**KAWARTHA PINE RIDGE DISTRICT SCHOOL BOARD
PUR24-087-ITT
Clarke High School Classroom Refresh**

ADDENDUM NO. 2

Project No.: 24035
Date: May 9, 2024
Tender No.: PUR24087-ITT
Project: **RECONFIGURATION CLASSROOMS AT CLARKE HIGH SCHOOL**
Kawartha Pine Ridge District School Board

1
A208 PART SECOND FLOOR PLAN (200,201,202,203,204)
1:50

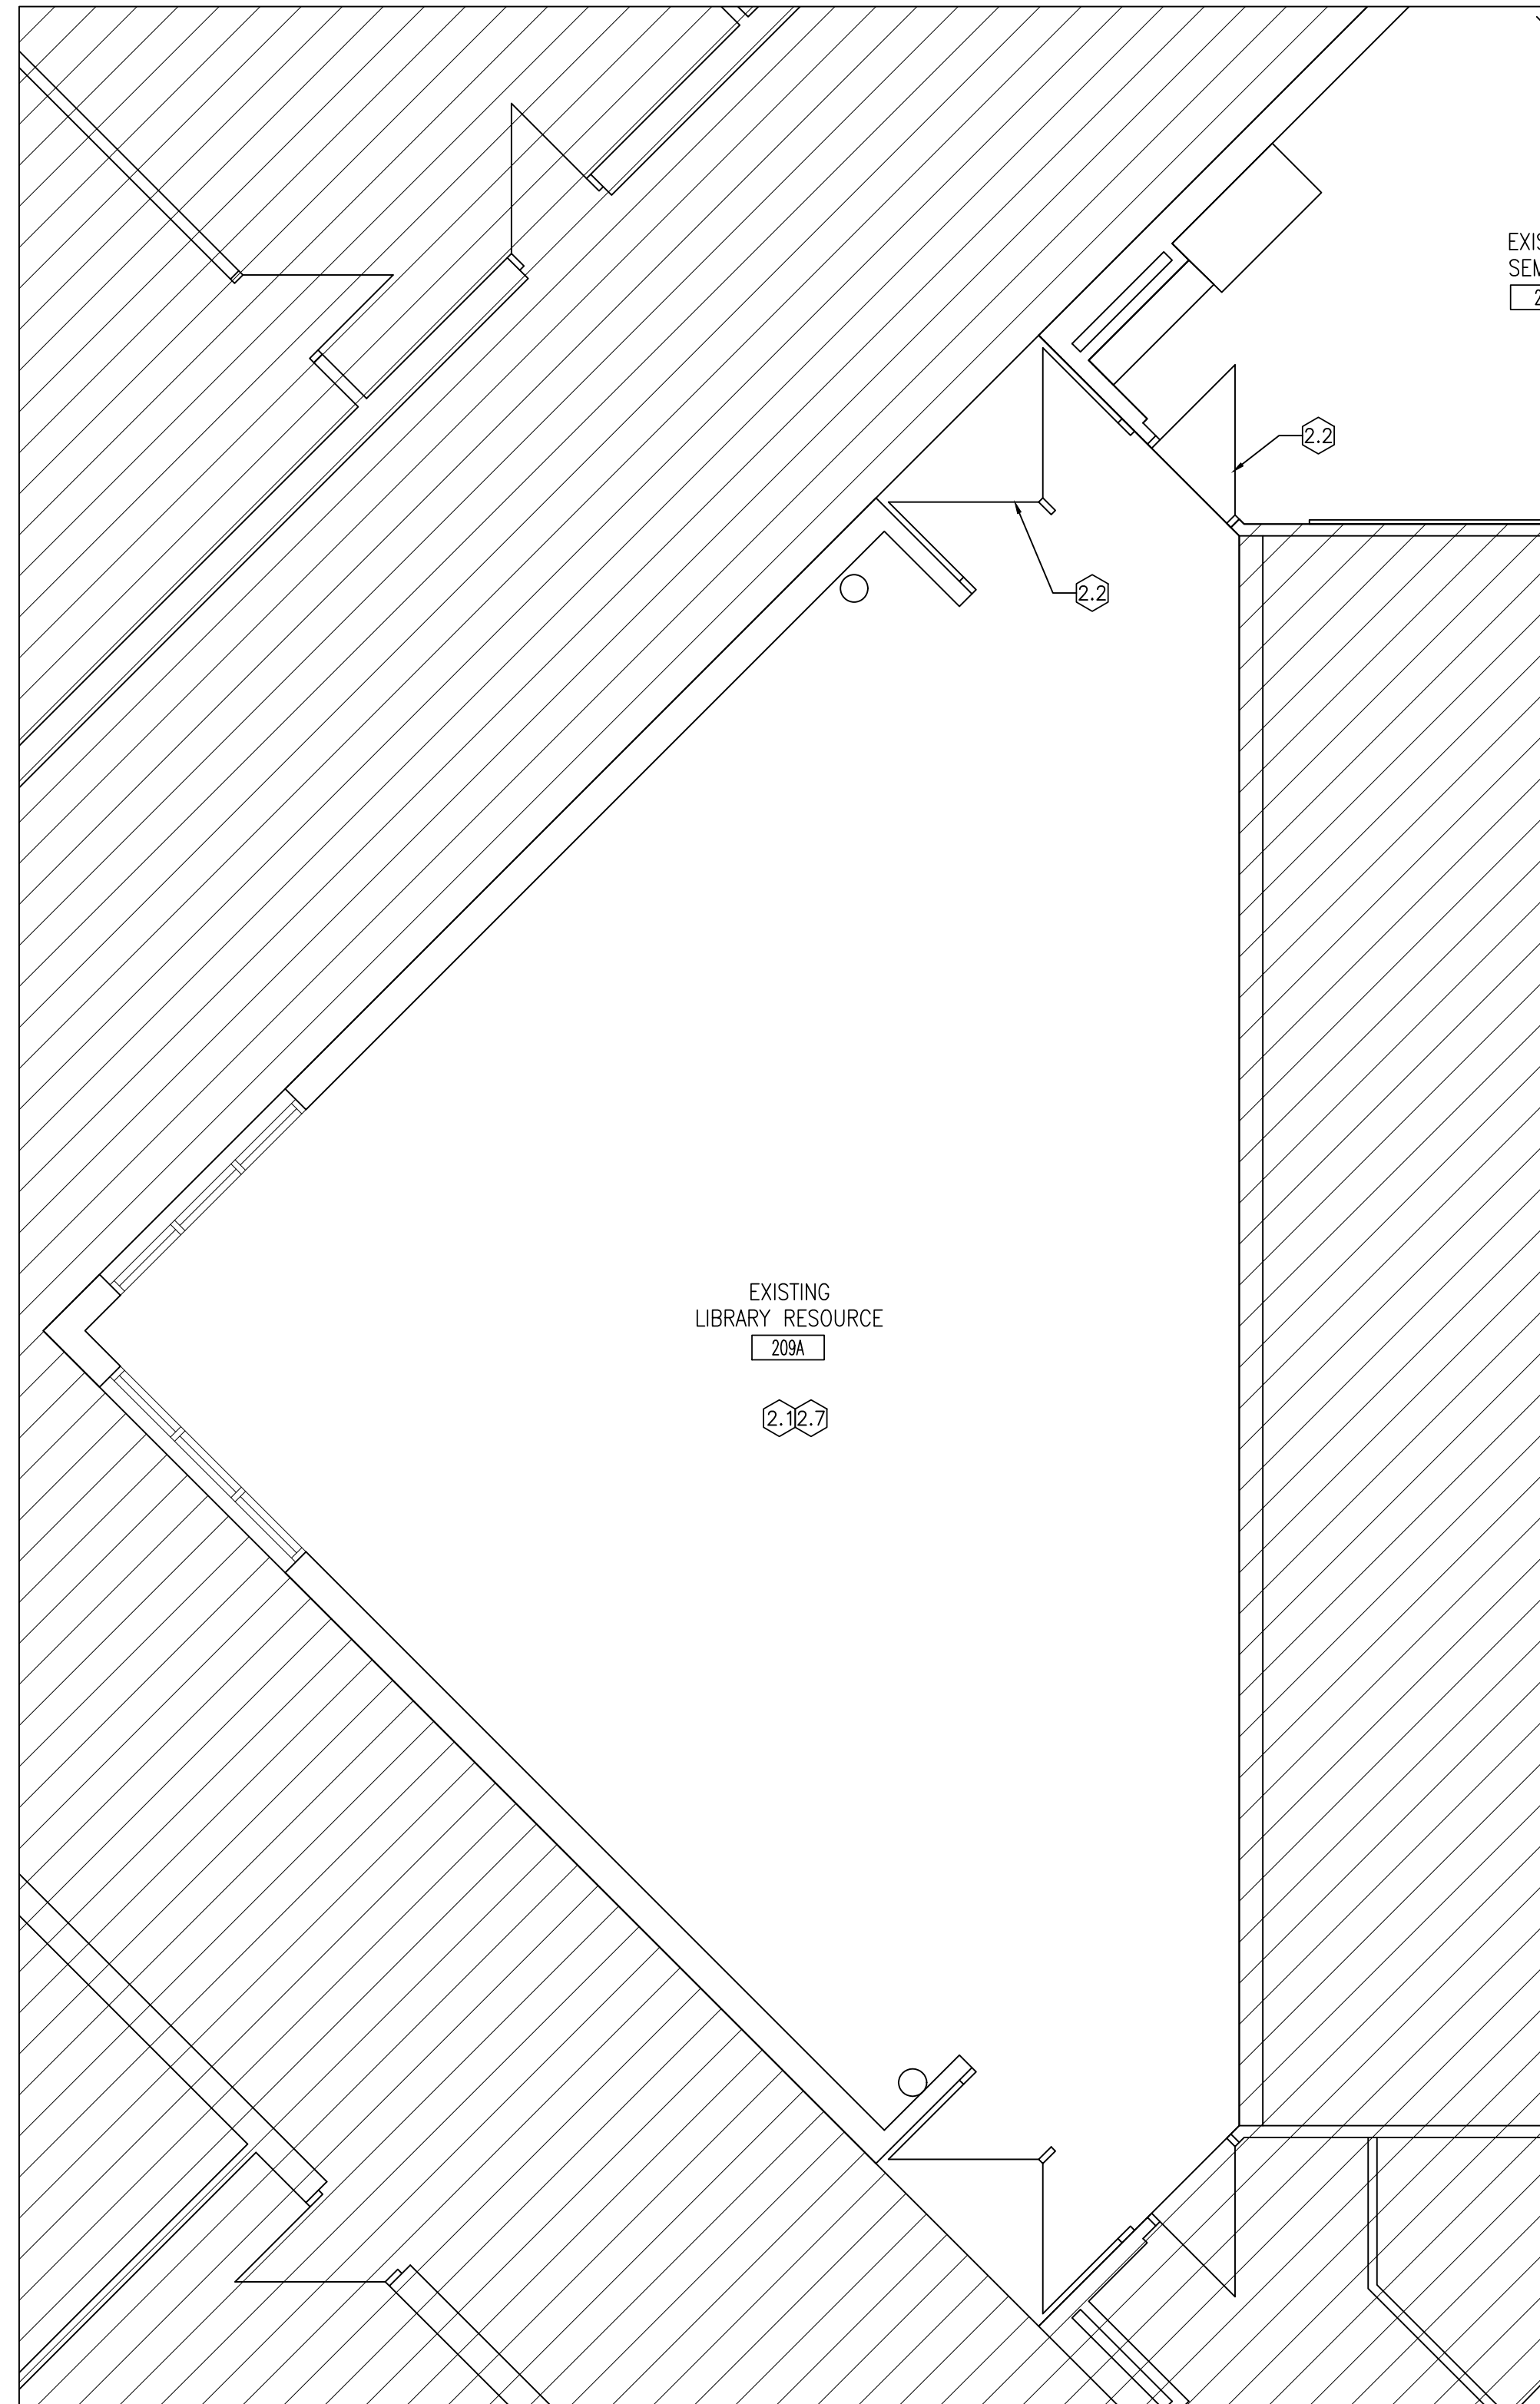
1.3 DRAWING SHEET A208 PART SECOND FLOOR PLAN

- .1 Addition of interior elevation tags.

1
A209 PART SECOND FLOOR PLAN (206,208)
1:50

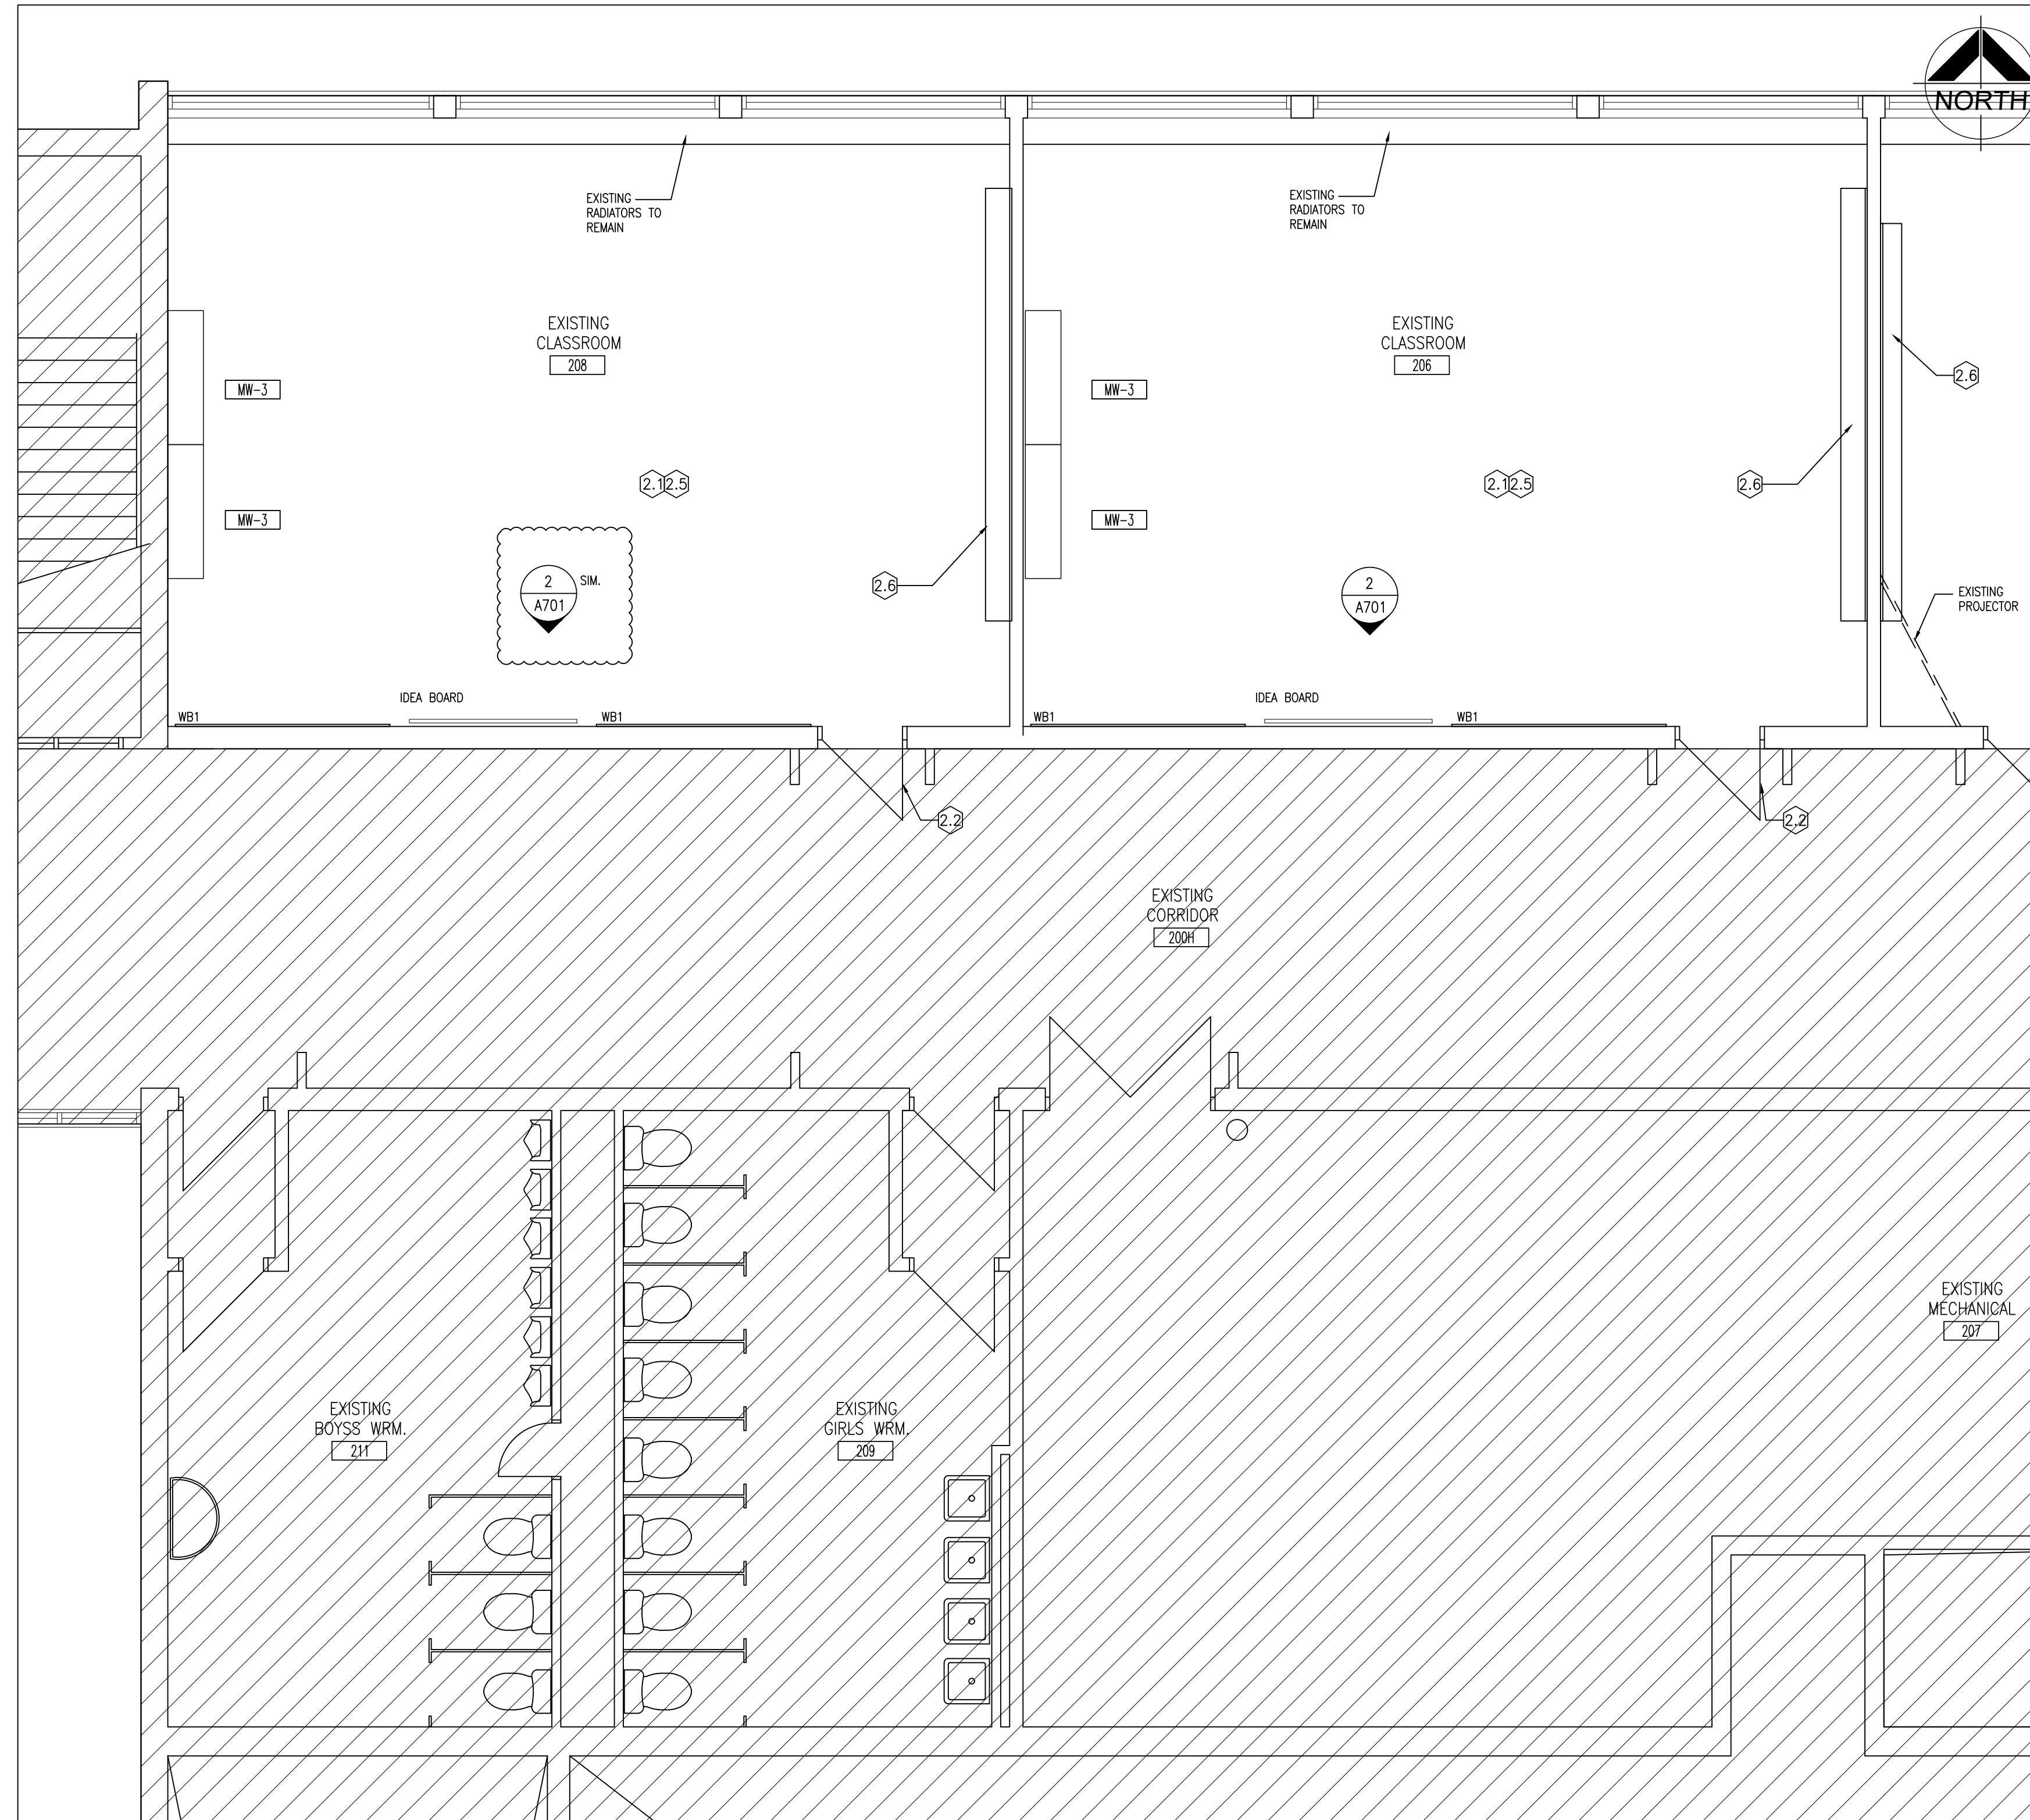
1.4 DRAWING SHEET A209 PART SECOND FLOOR PLAN

- .1 Addition of interior elevation tags.

1 PART SECOND FLOOR REFLECTED CEILING PLAN (200,201,202,203,204,205)
A212 1:50

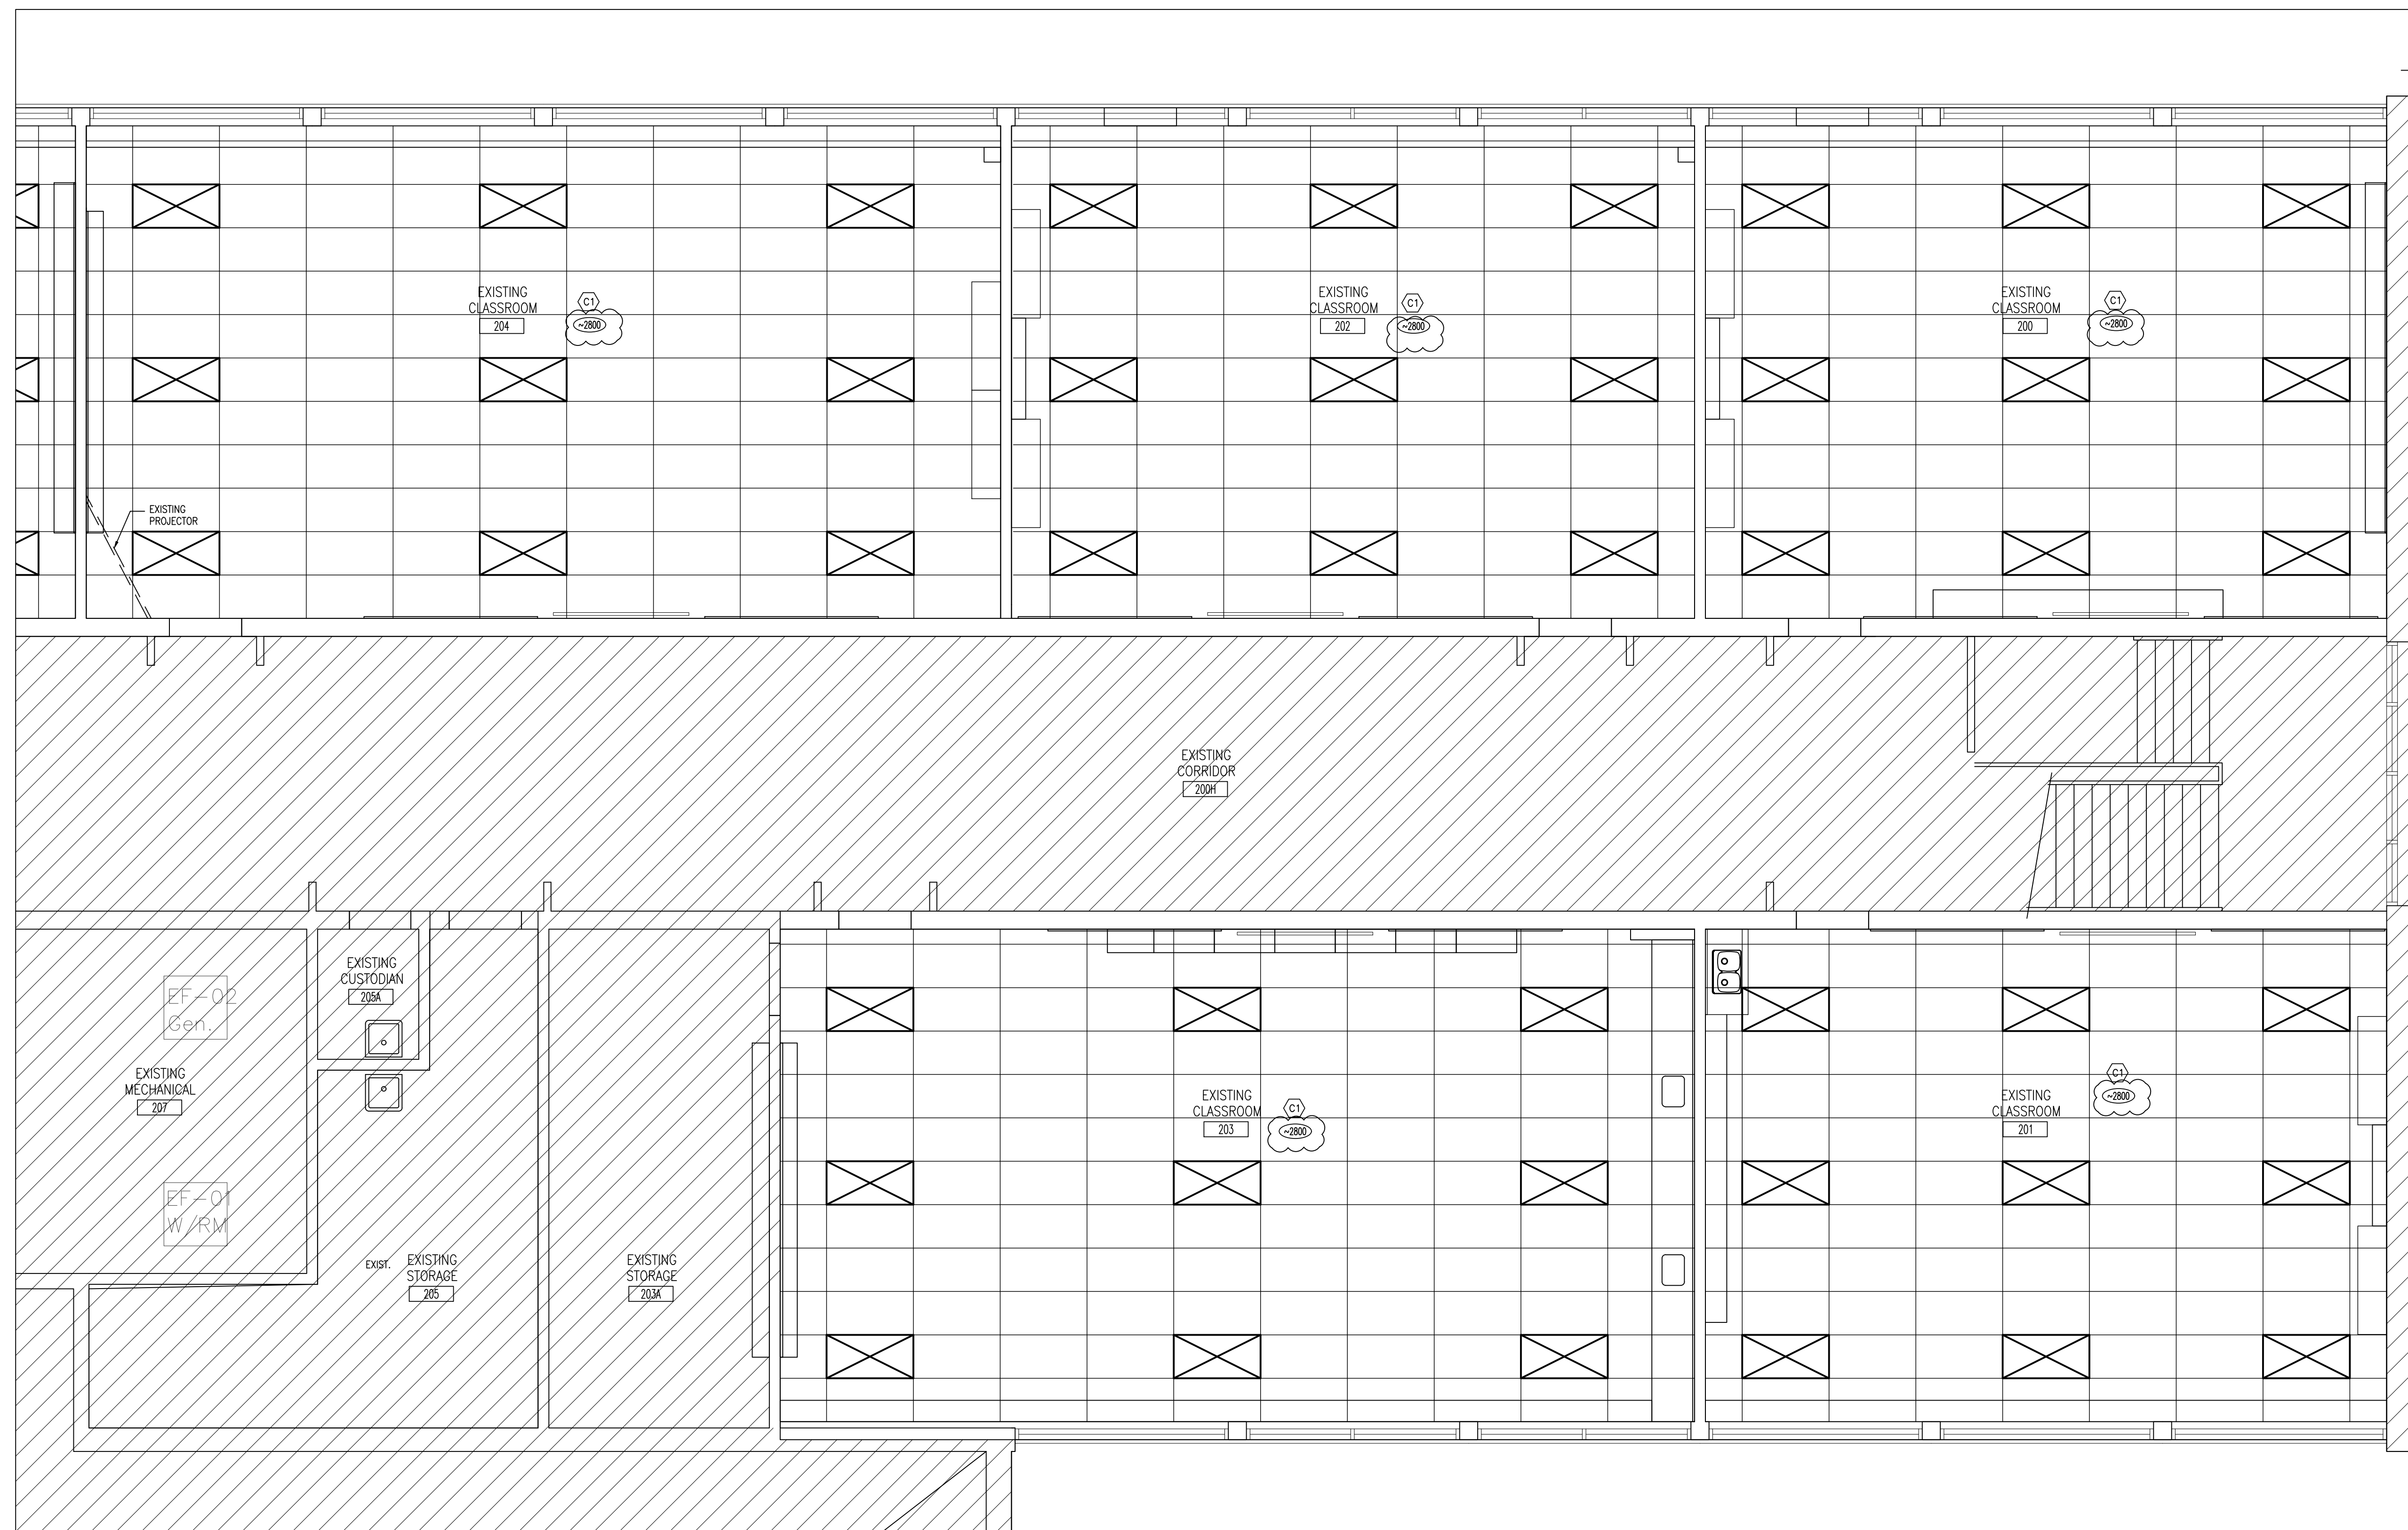
1.5 DRAWING SHEET A212 PART FIRST FLOOR REFLECTED CEILING PLAN

- .1 Revised "C1" ceiling type height and description.

1.9 **Question:** Abatement is removing 12x12 ceiling tiles. Are we leaving the existing assumed gypsum backing and framing with new t-bar below New ceiling C1 does not note any gypsum board in the assembly.

Answer: The abatement contractor is responsible for the removal of existing 12x12 tile and glue. The general contractor is to remove the existing drywall ceiling (if there is one). New ceiling "C1" suspended ceiling is a 1HR fire rated assembly.
